DOCUMENT TRANSMITTAL 2003-55088

TRM1 - TECHNICAL REQUIREMENTS MANUAL UNIT 1

Susquehanna SES Unit 1 Cycle 13

CORE OPERATING LIMITS REPORT

SSES UNIT 1 CYCLE 13

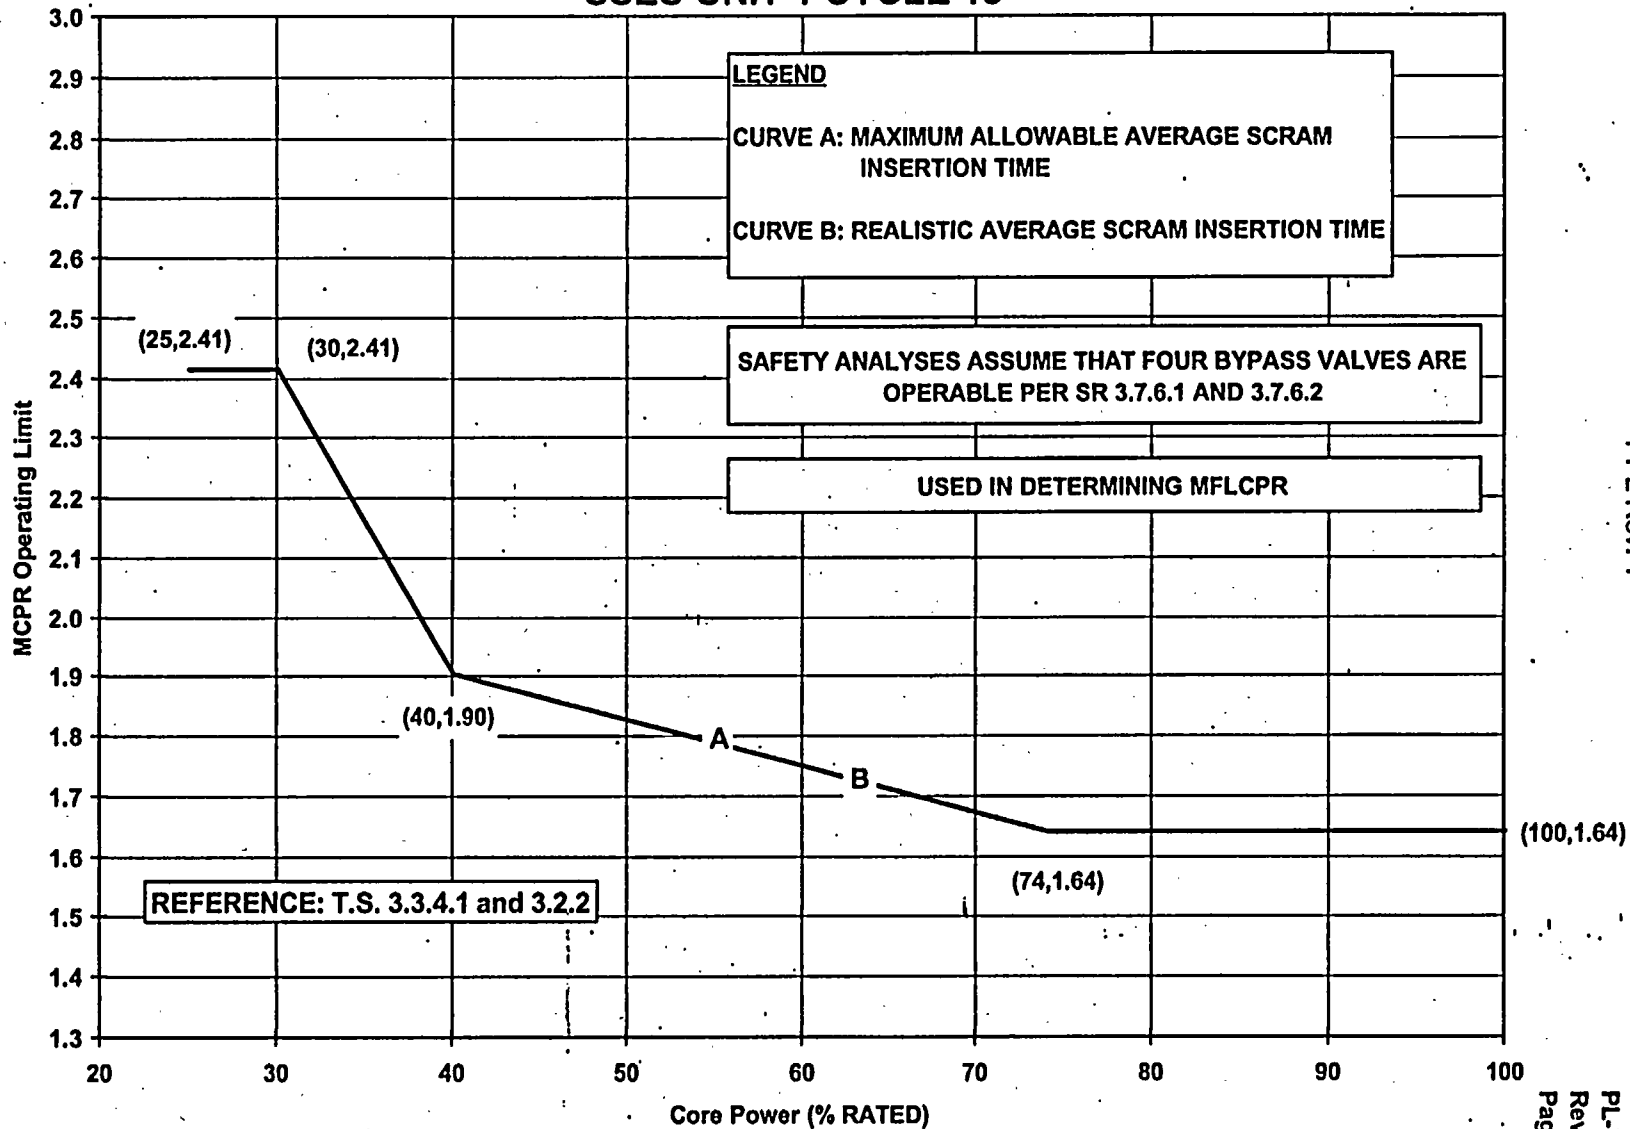
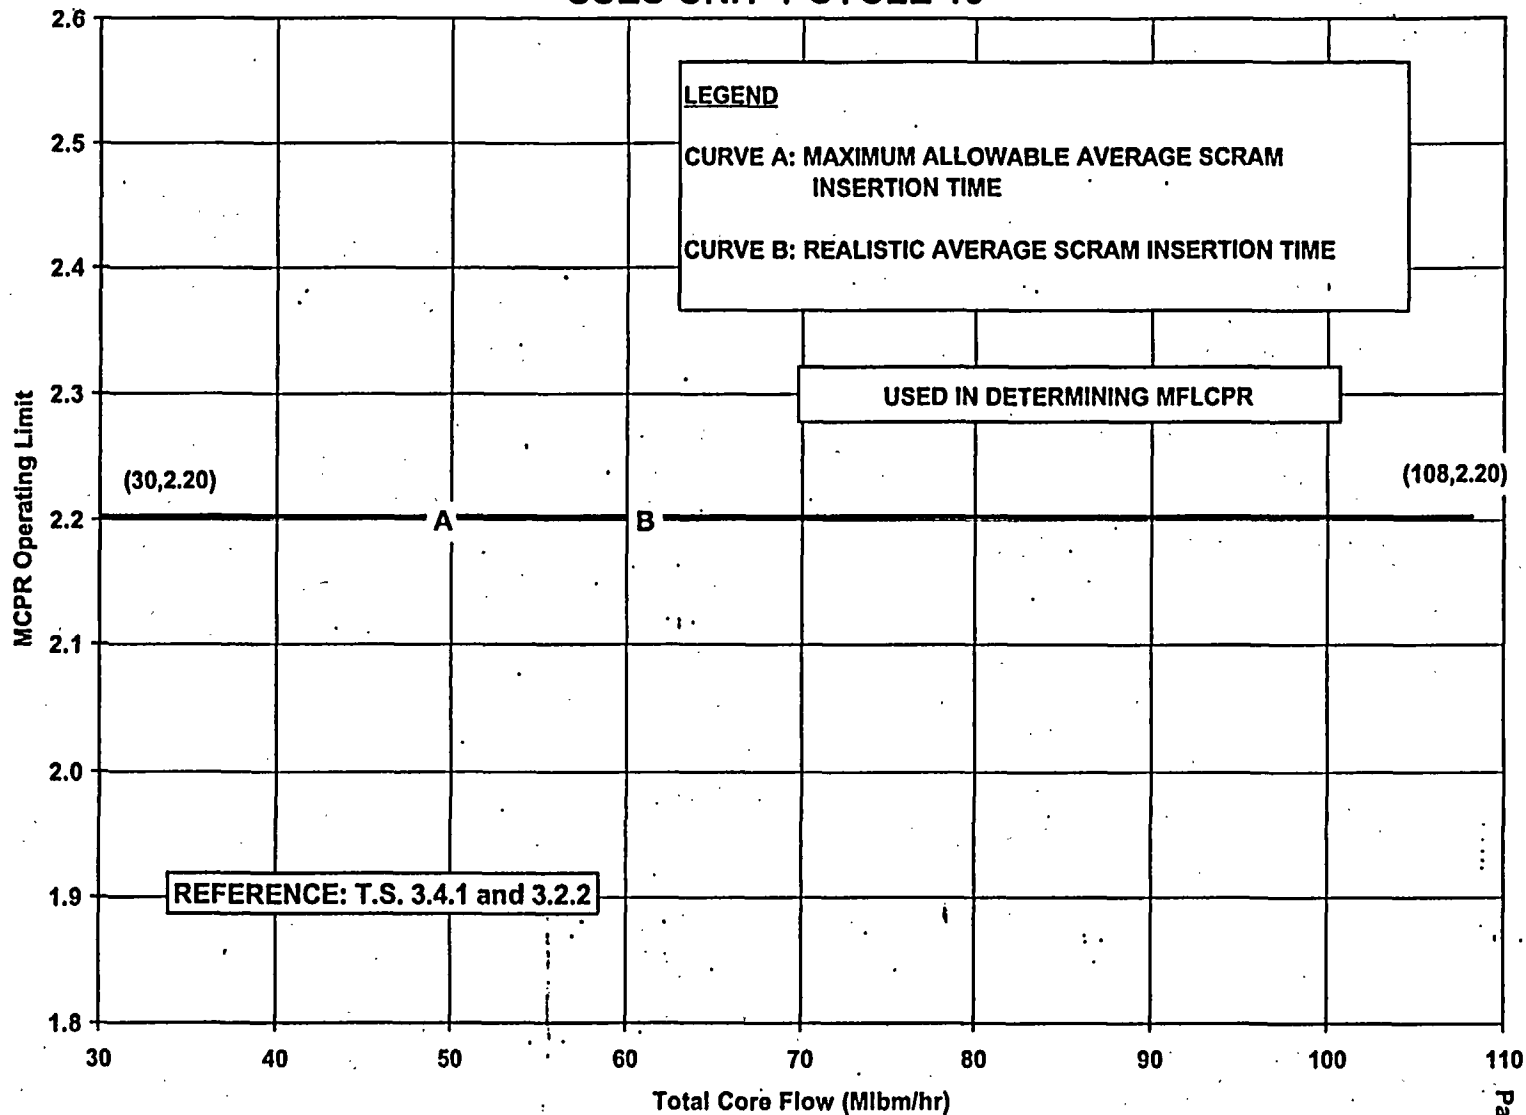
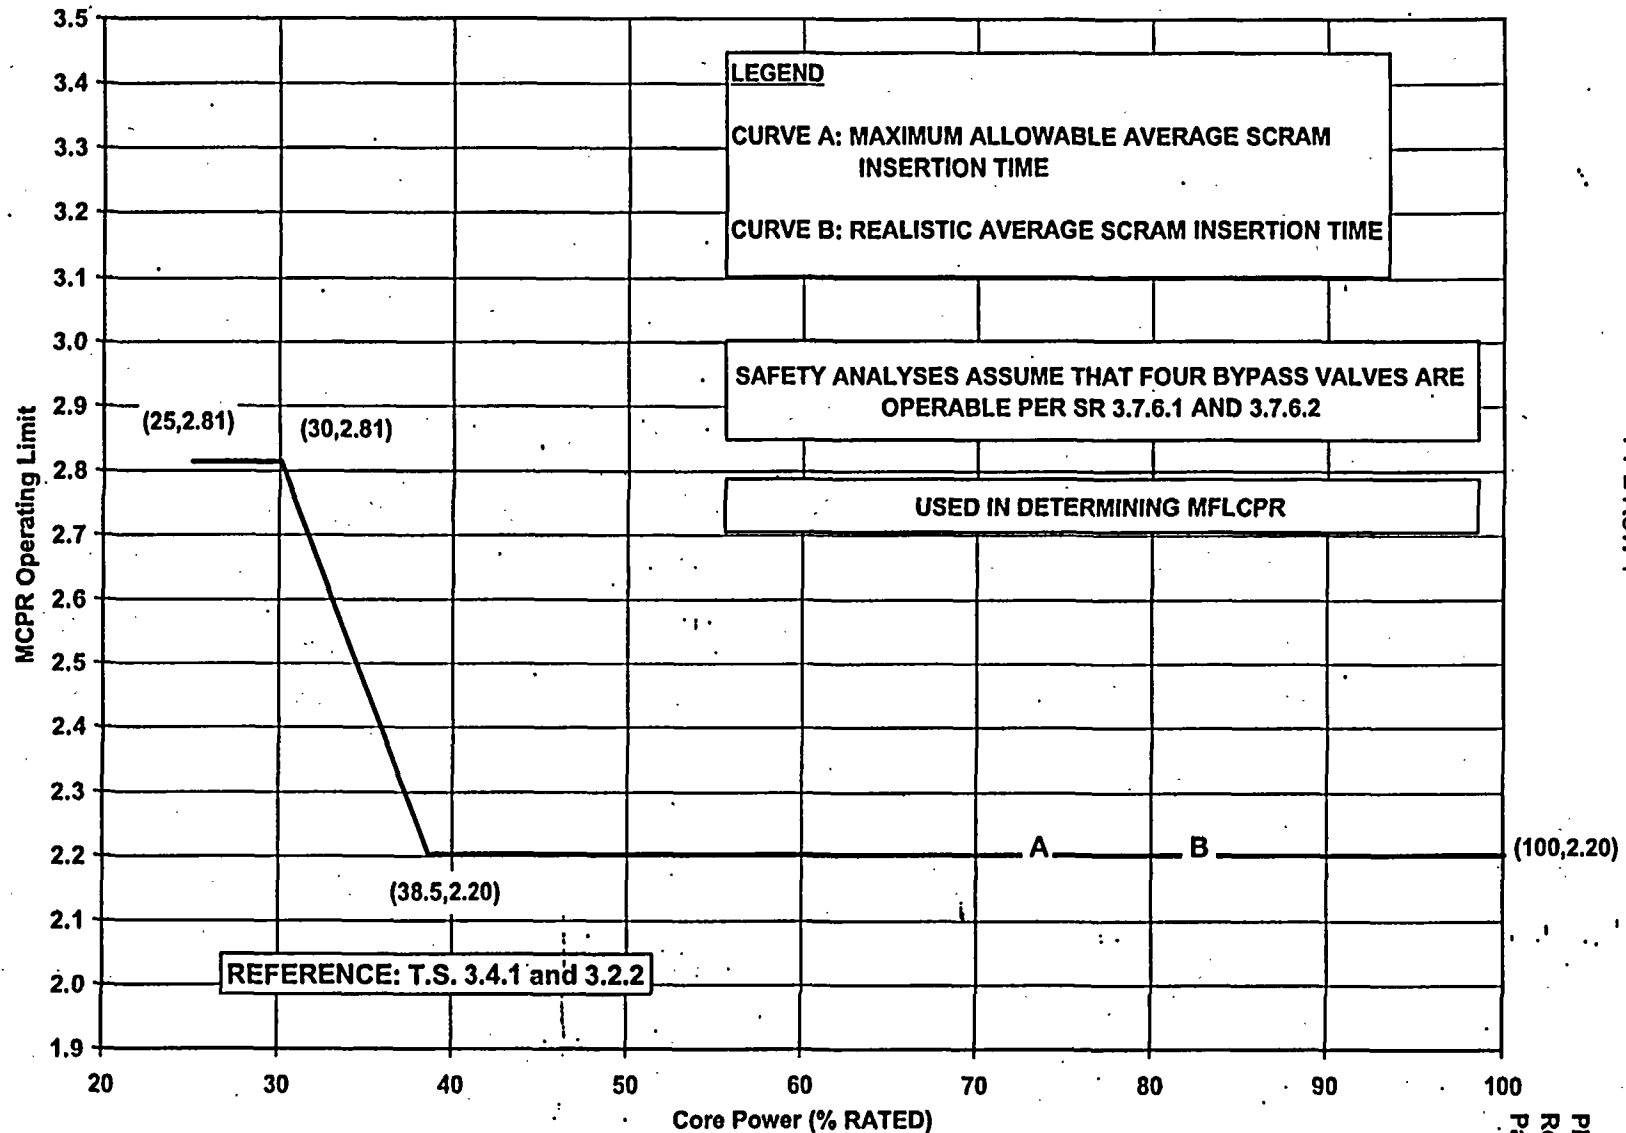
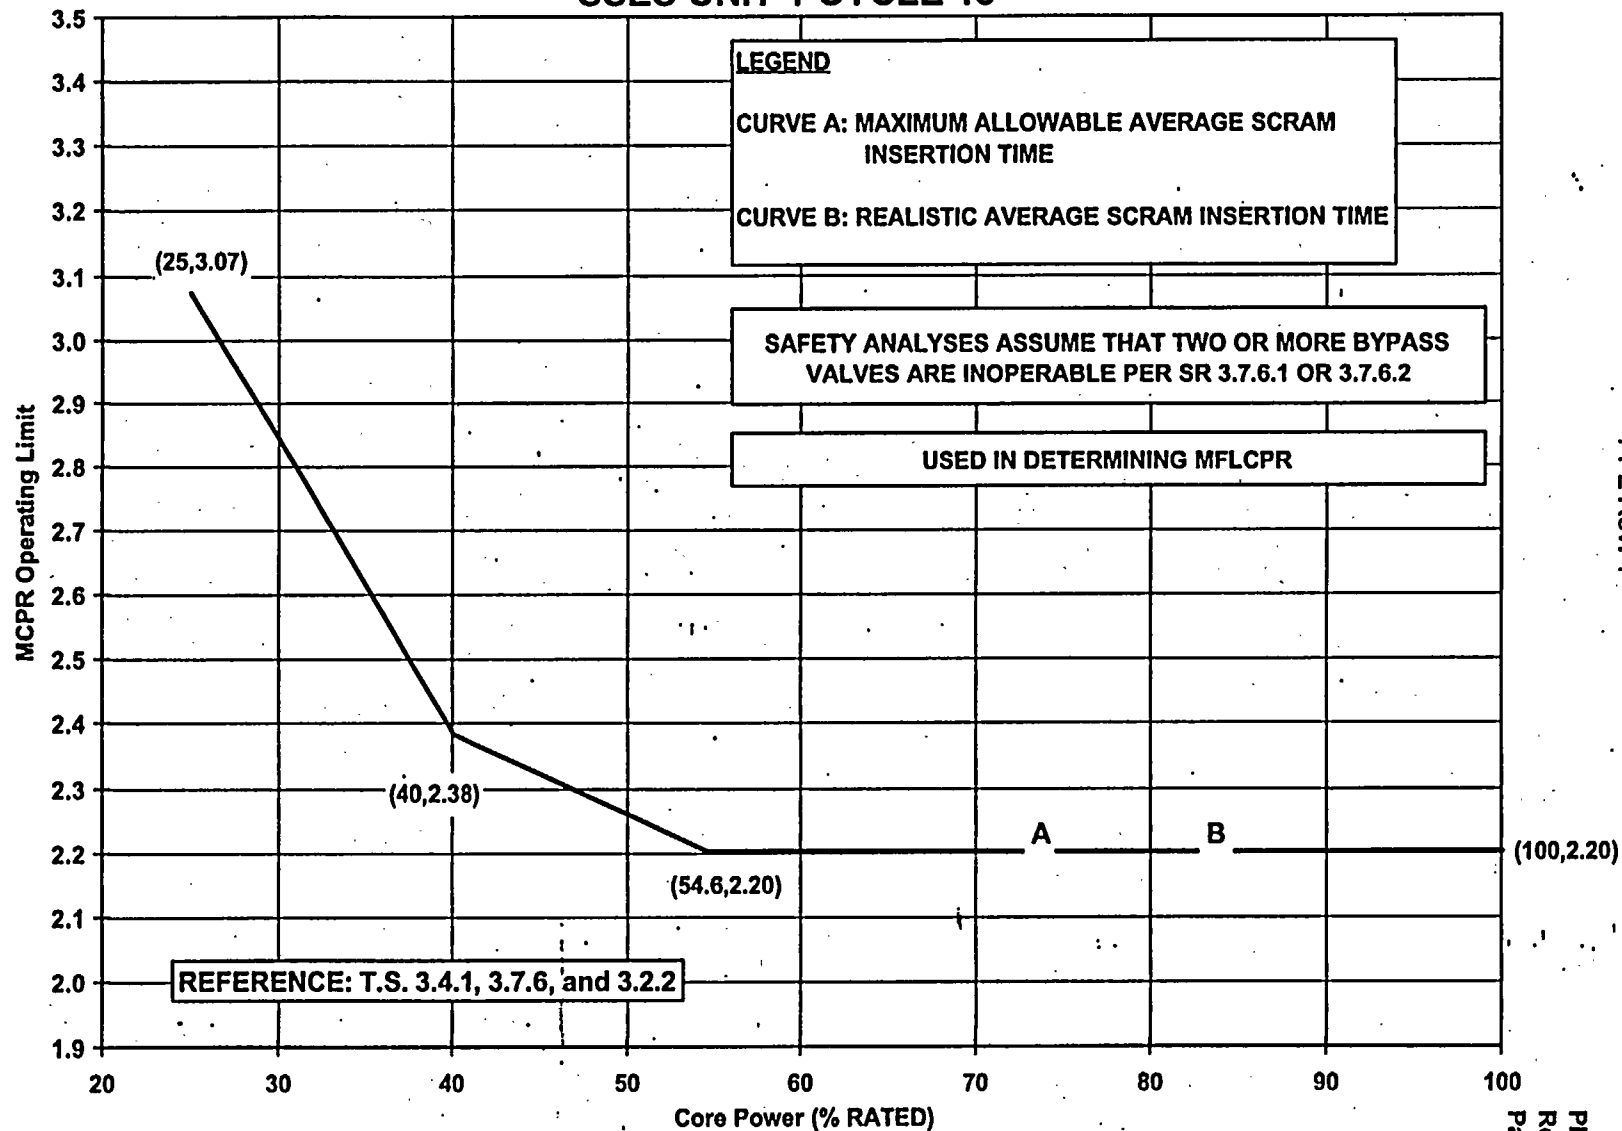
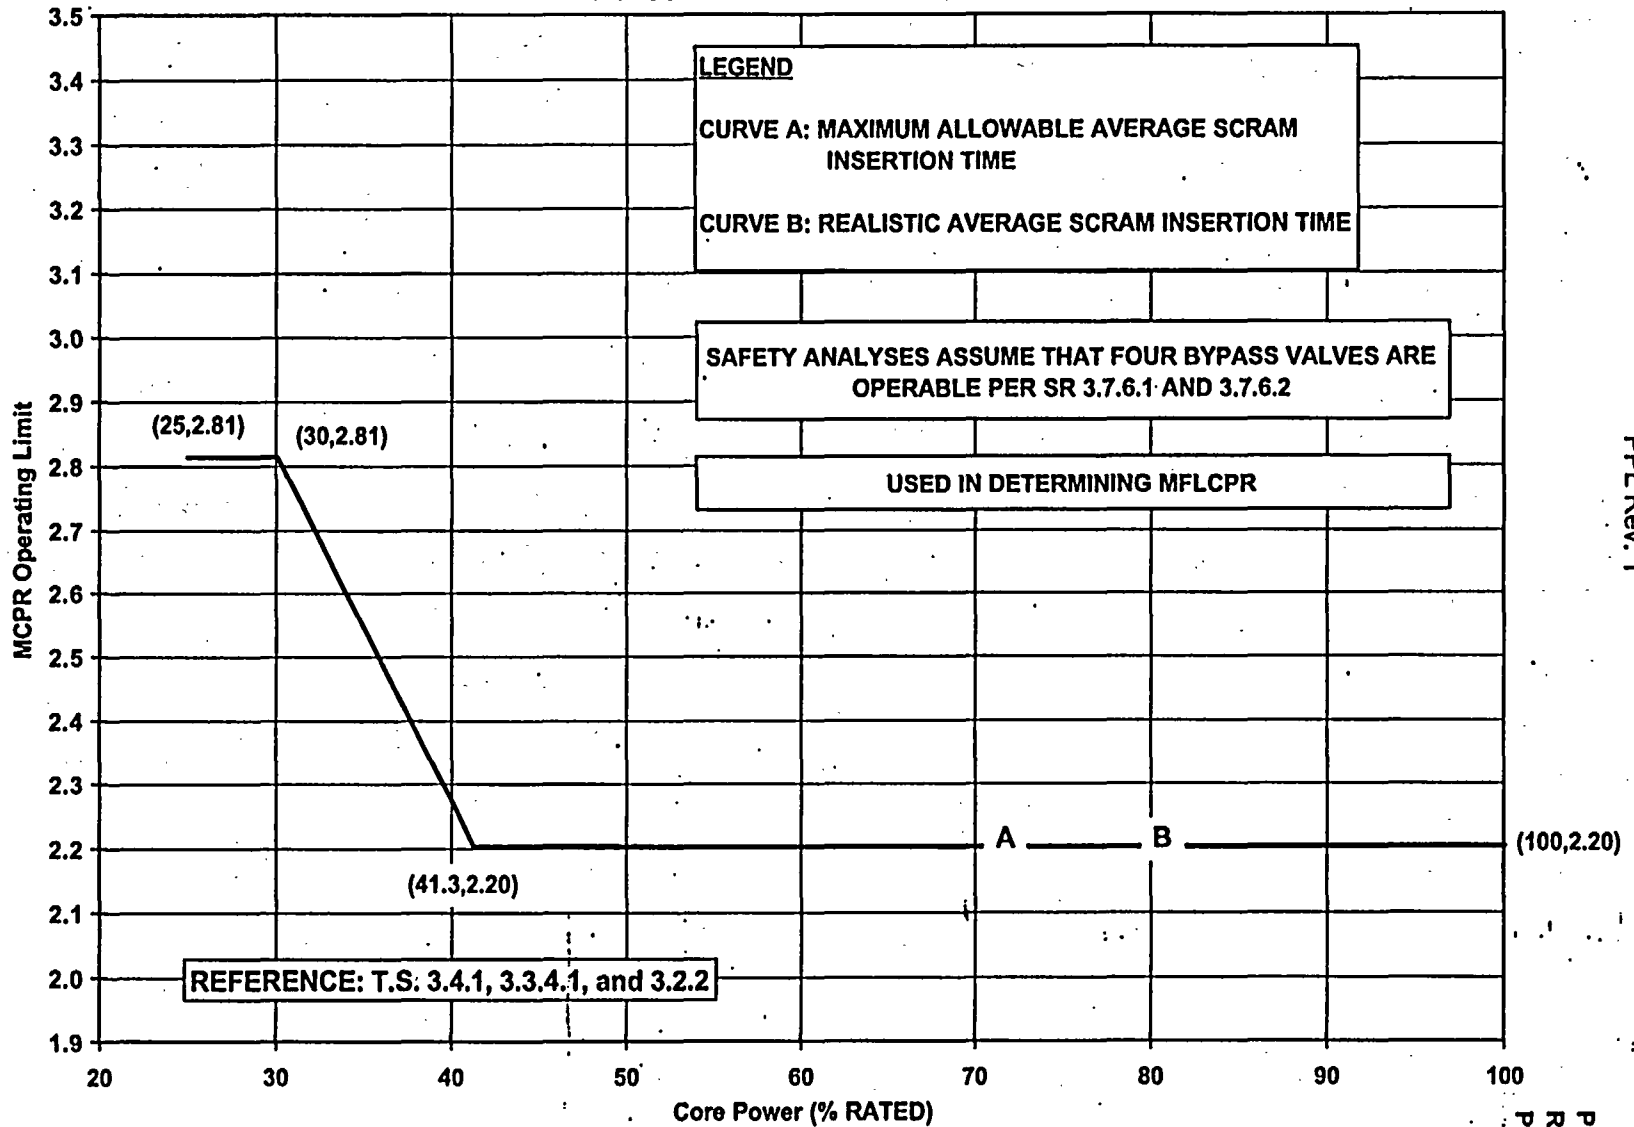
Rev. No.	Affected Sections	Description/Purpose of Revision
0	ALL	Issuance of this COLR is in support of Unit 1 Cycle 13 operation.
1	5.0 6.0 8.0	<p>This revision adds a text box to all appropriate plots. This text box indicates that for all bypass operable cases, four bypass valves are assumed operable. For the bypass inoperable cases, the text box indicates that two or more bypass valves are assumed inoperable.</p> <p>This revision was generated in response to Facility Operating License Amendment 210 which altered SR 3.7.6.1.</p> <p>This revision is administrative in nature and no underlying calculations or plotted data were altered.</p>
2	TOC 1.0 9.0 10.0	<p>This revision adds the Power / Flow map to the COLR. Section 1.0 was revised to include the stability regions as part of the COLR. The Power / Flow map was added as Section 9.0. The Reference section was renumbered as Section 10.0 and a stability reference added.</p> <p>This revision is administrative in nature since the Power / Flow map is already included in NDAP-QA-0338.</p>
